Site Design for a Hotel on Pantops, Charlottesville

A Technical Report submitted to the Department of Civil & Environmental Engineering

The Site Design for a Hotel on Pantops, Charlottesville Final Report

PANTOPS HOTEL
 CHARLOTTEVILLE, VA
EXISTING CONDITIONS

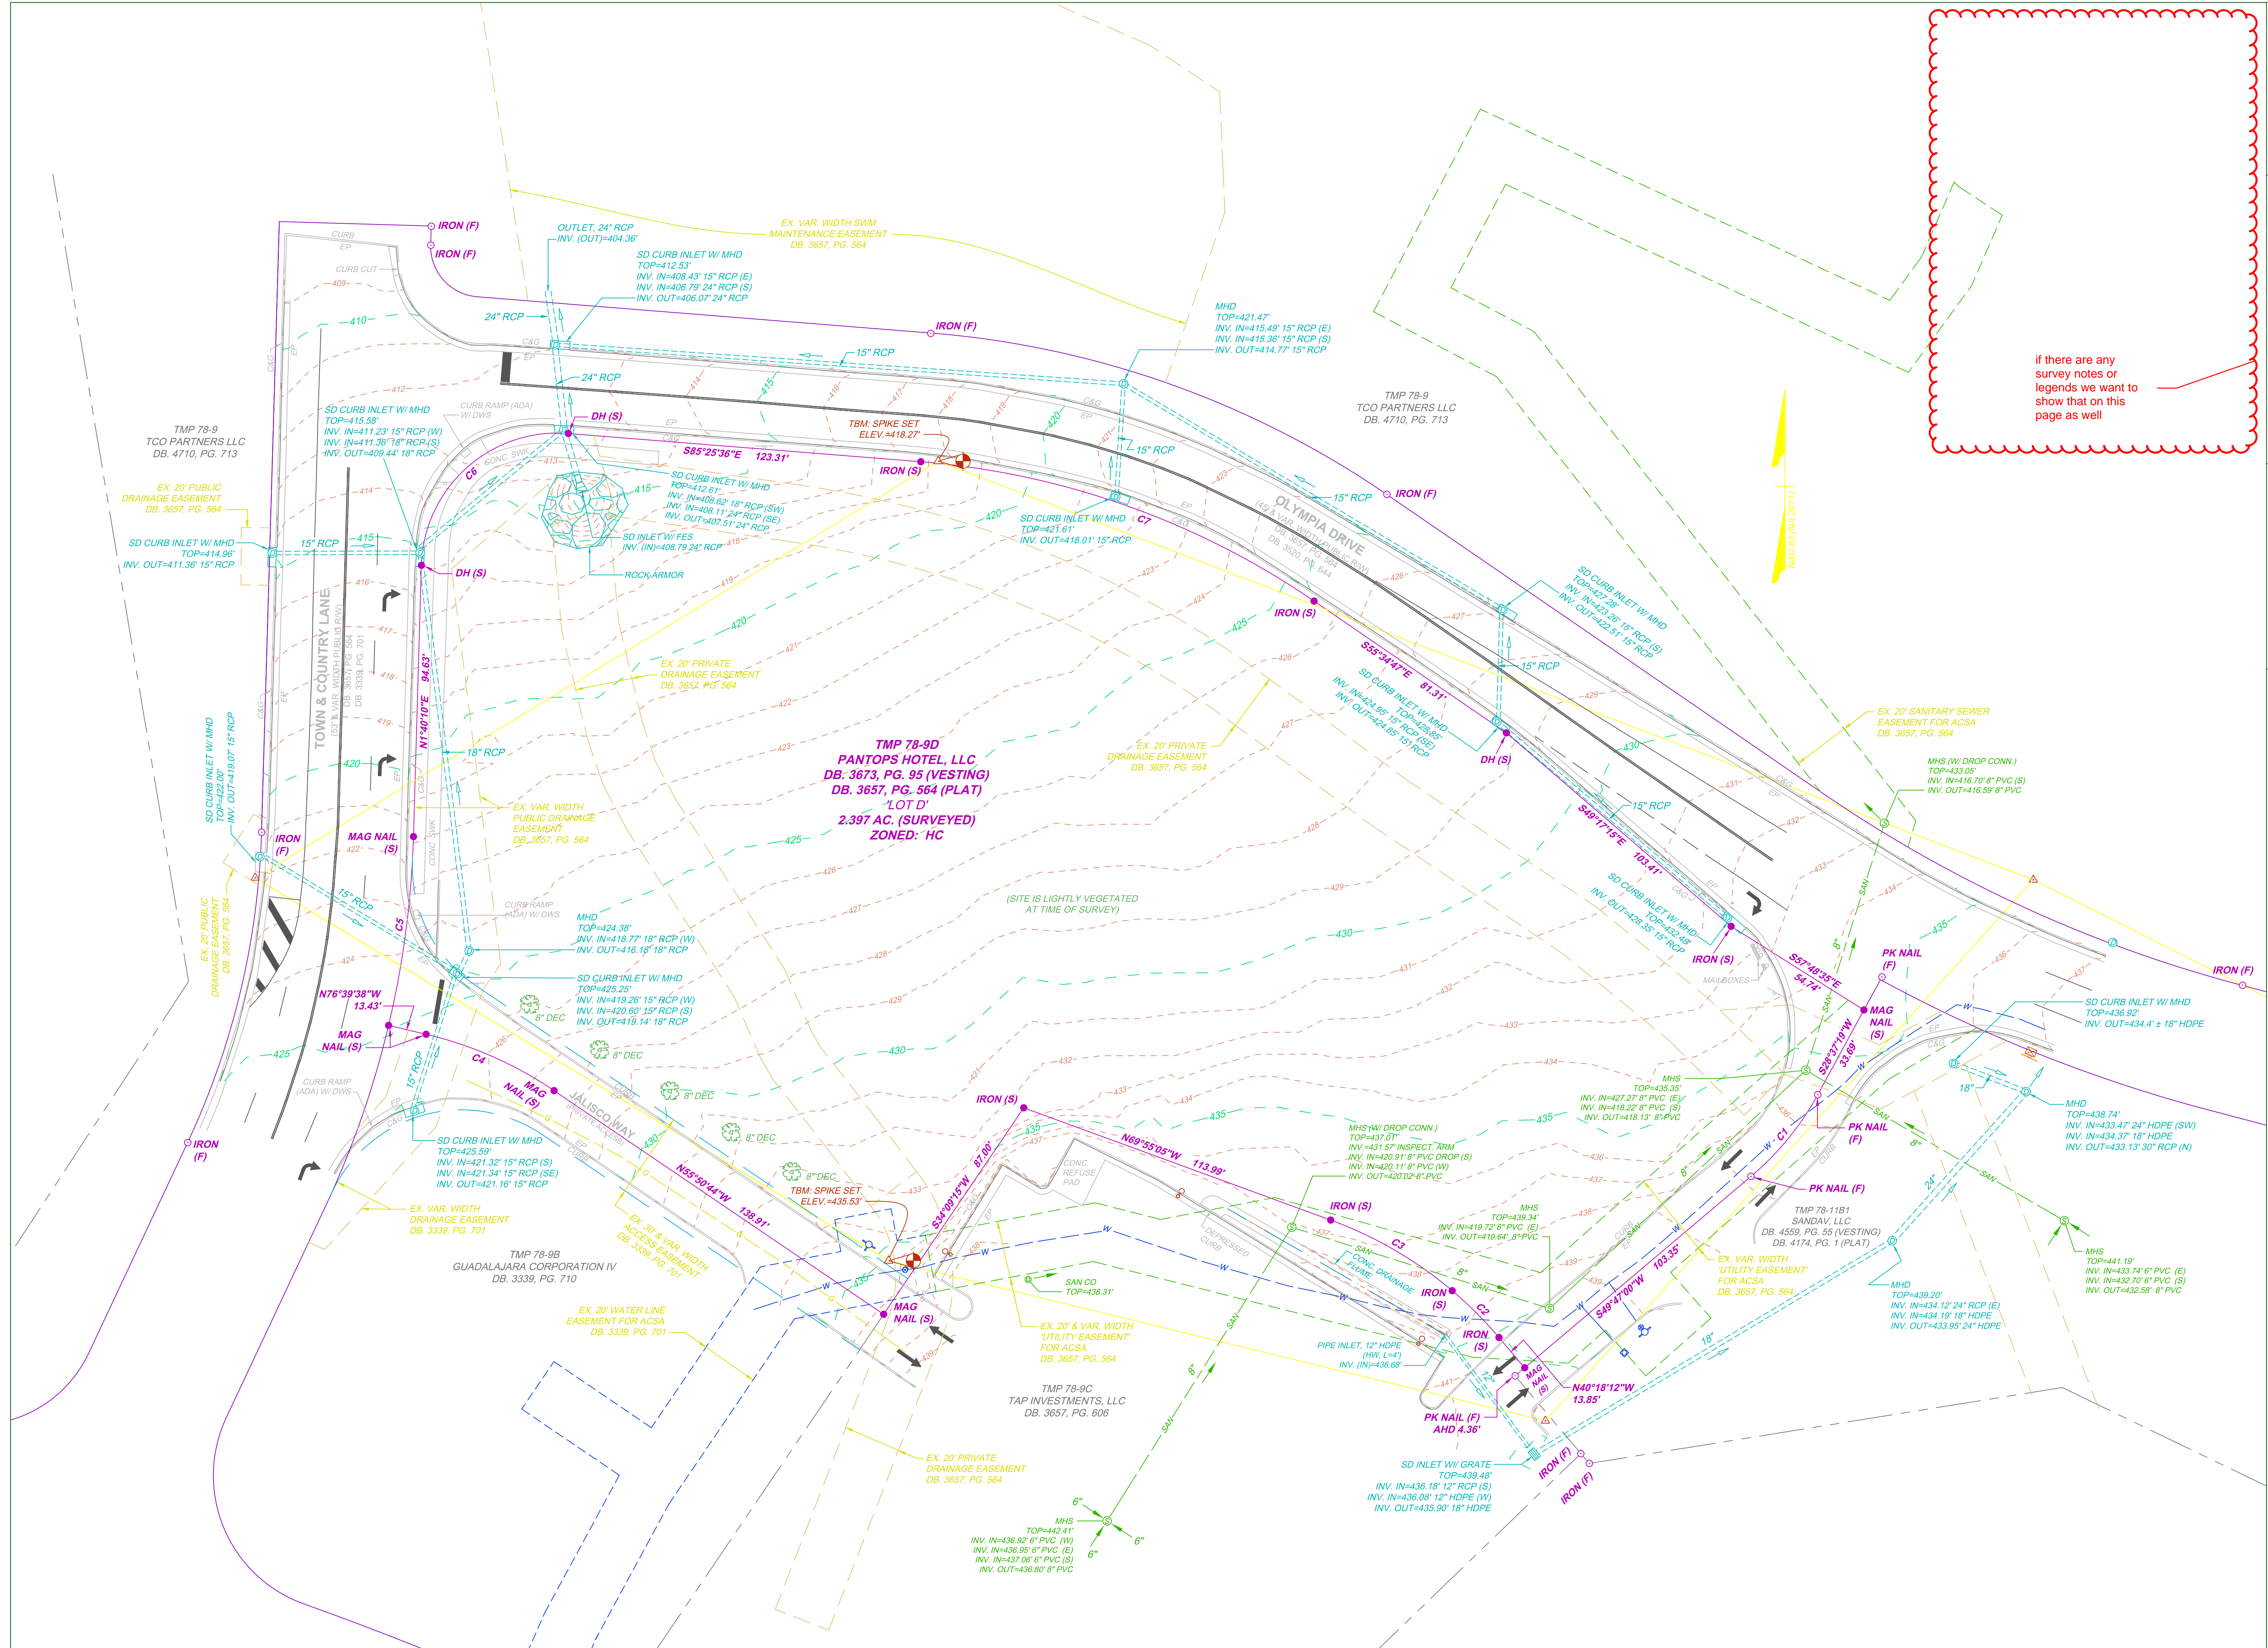
if there are any survey notes or legends we want to show that on this page as well

JOB NO. _____
SHEET NO. **4**

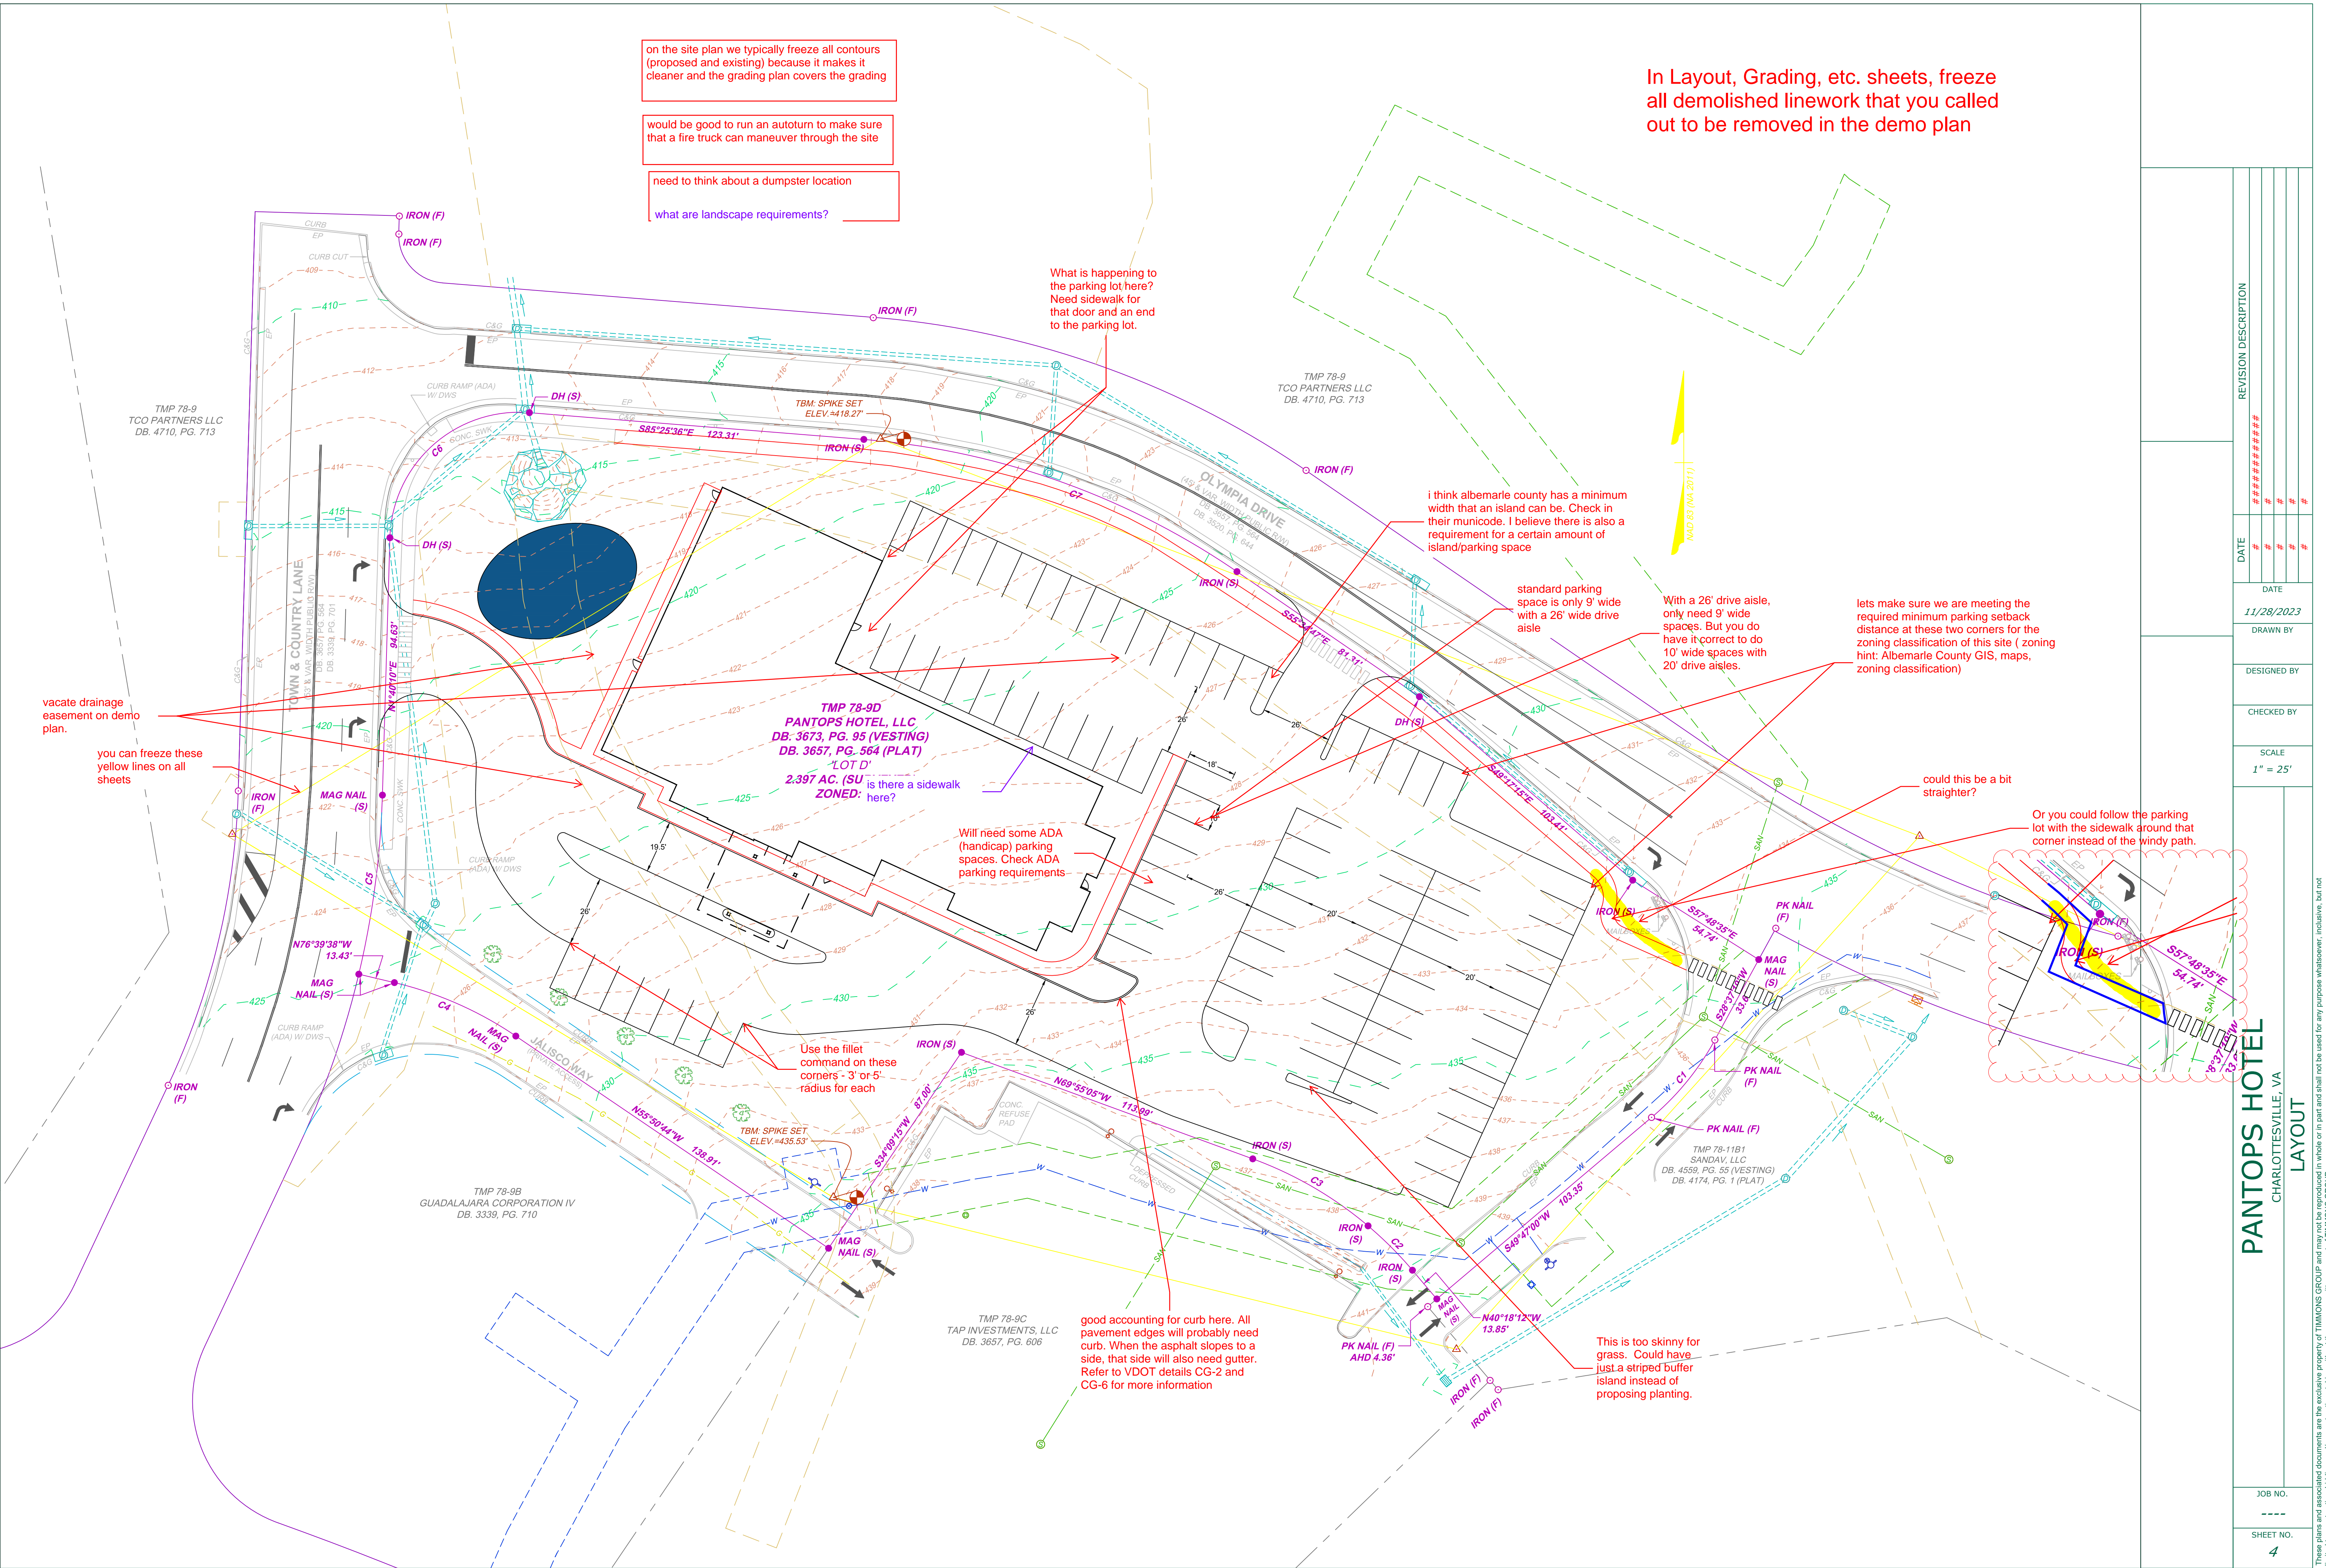
In Layout, Grading, etc. sheets, freeze all demolished linework that you called out to be removed in the demo plan

Will need some ADA (handicap) parking spaces. Check ADA parking requirements

Use the fillet command on these corners - 3' or 5' radius for each

good accounting for curb here. All pavement edges will probably need curb. When the asphalt slopes to a side, that side will also need gutter. Refer to VDOT details CG-2 and CG-6 for more information

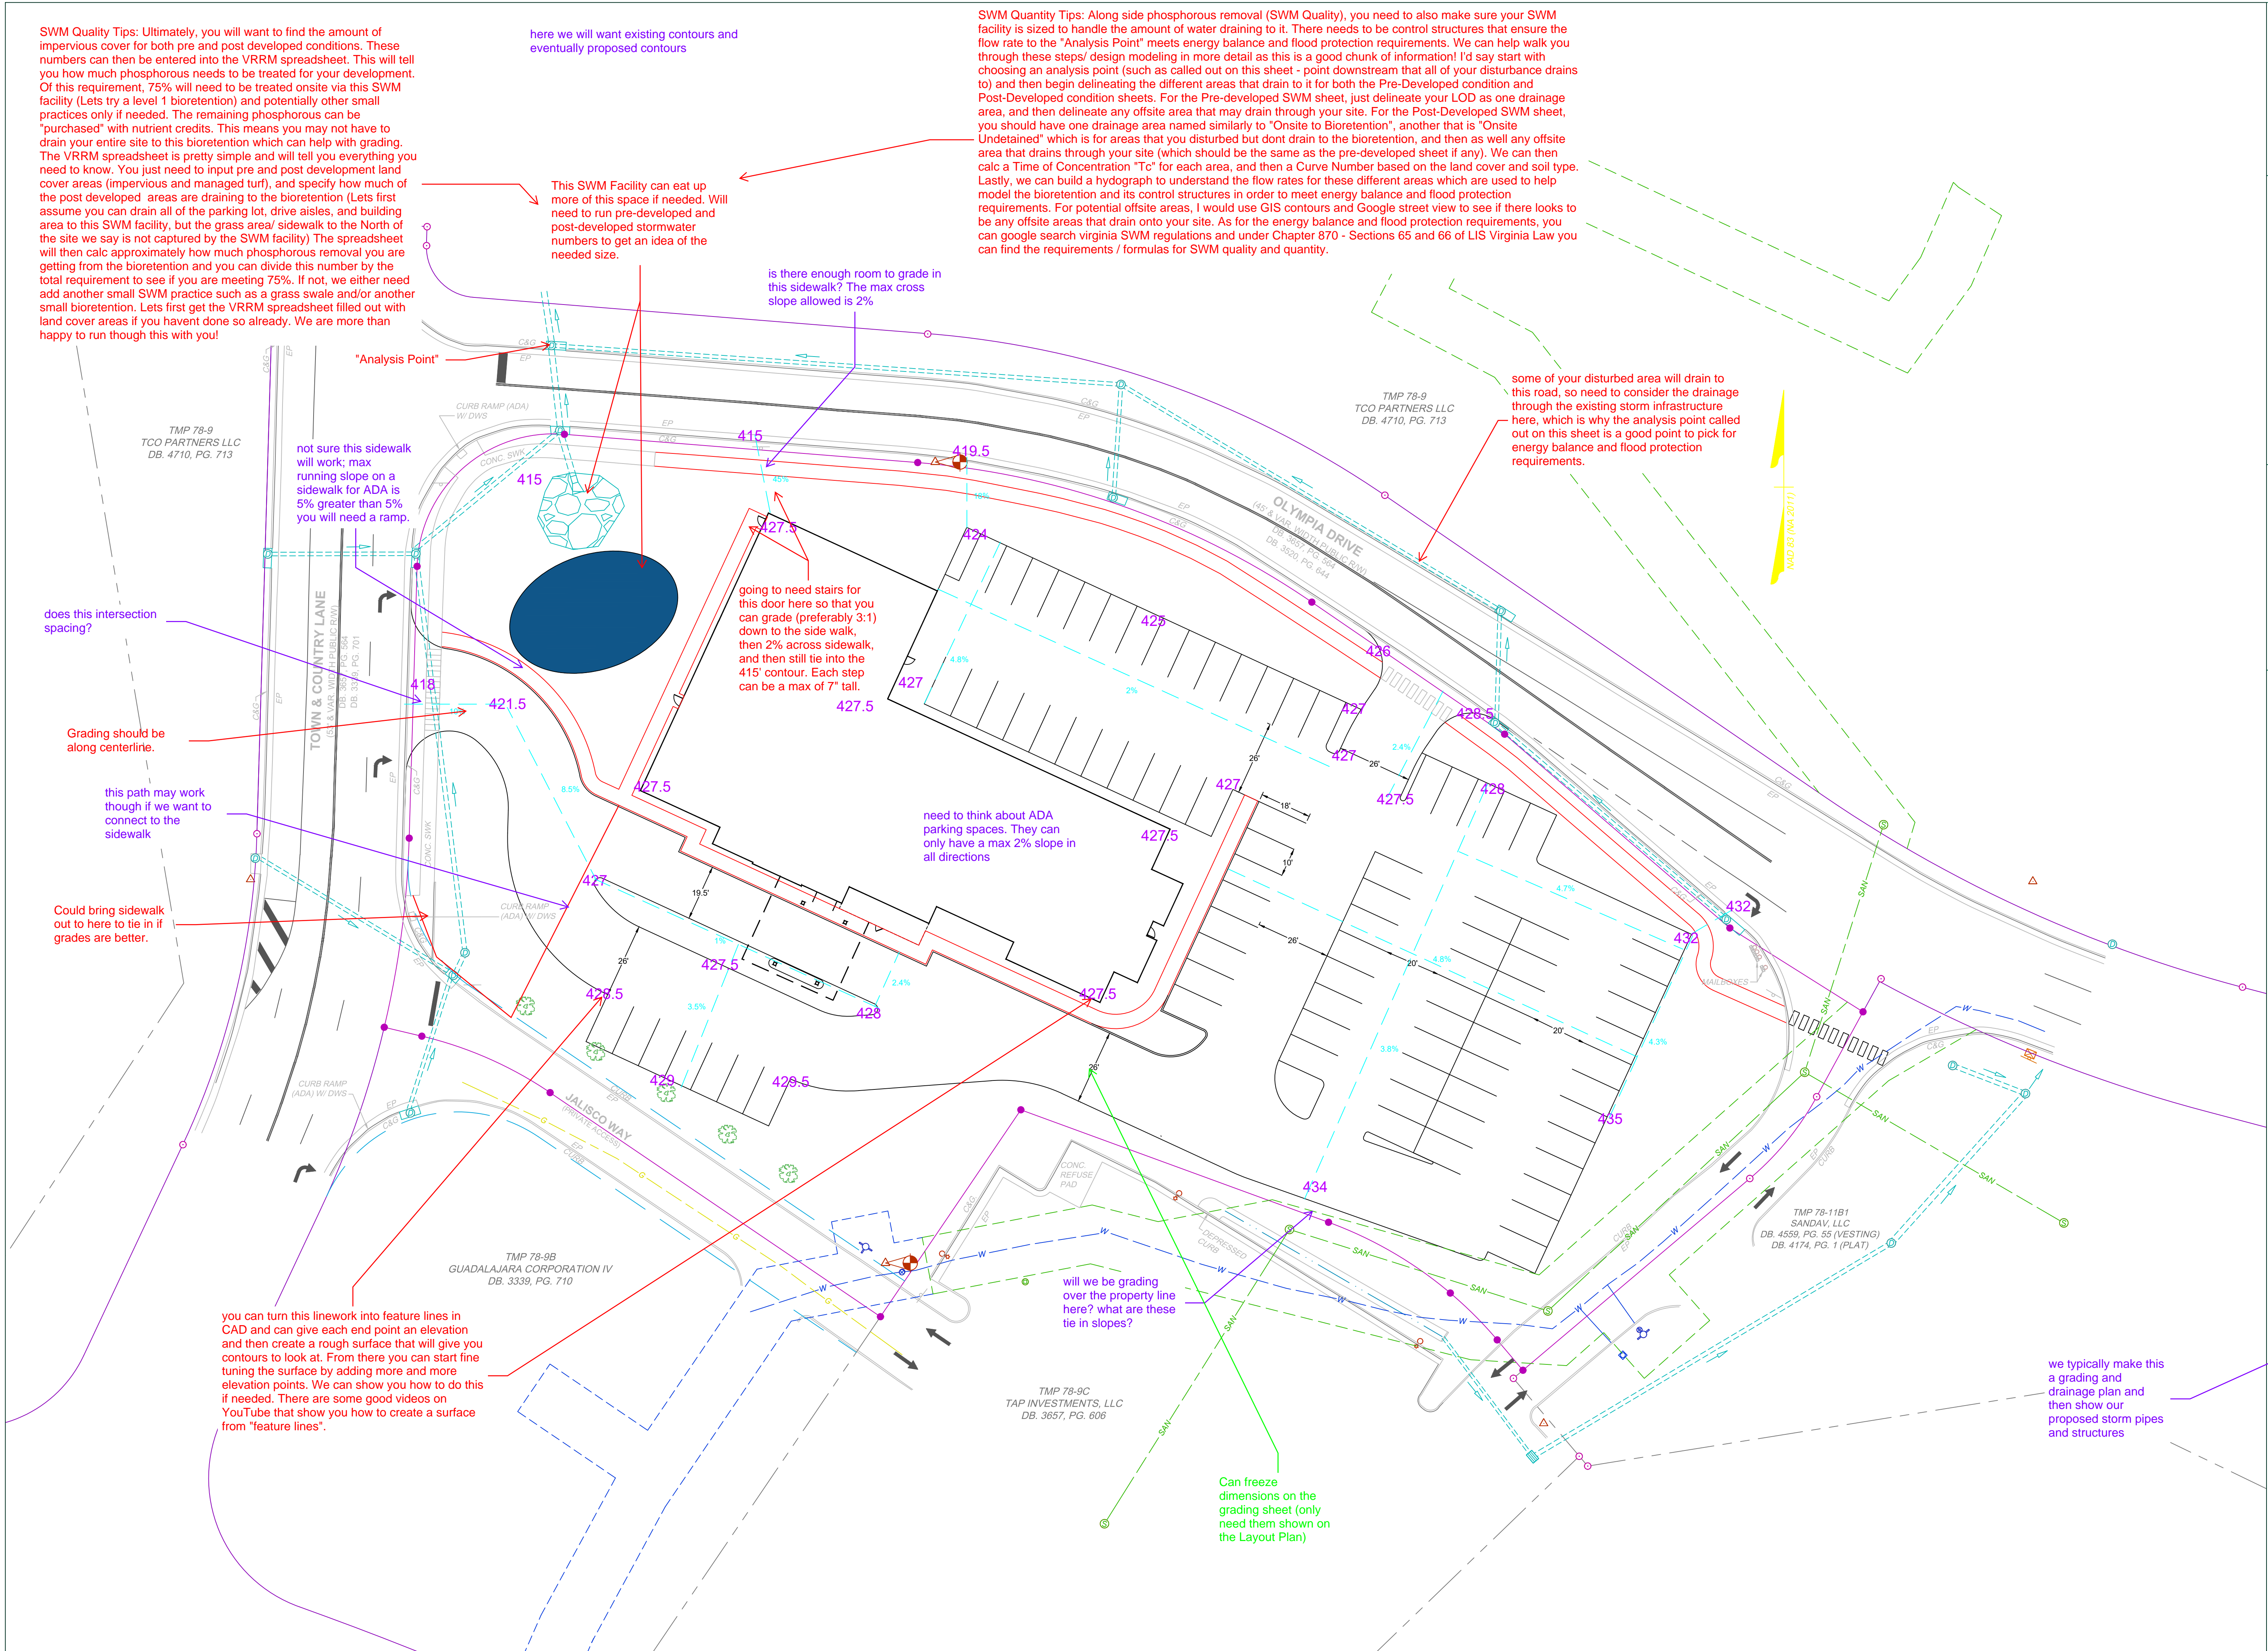
this path may work though if we want to connect to the sidewalk

Could bring sidewalk out to here to tie in if grades are better.

you can turn this linework into feature lines in CAD and can give each end point an elevation and then create a rough surface that will give you contours to look at. From there you can start fine tuning the surface by adding more and more elevation points. We can show you how to do this if needed. There are some good videos on YouTube that show you how to create a surface from "feature lines".
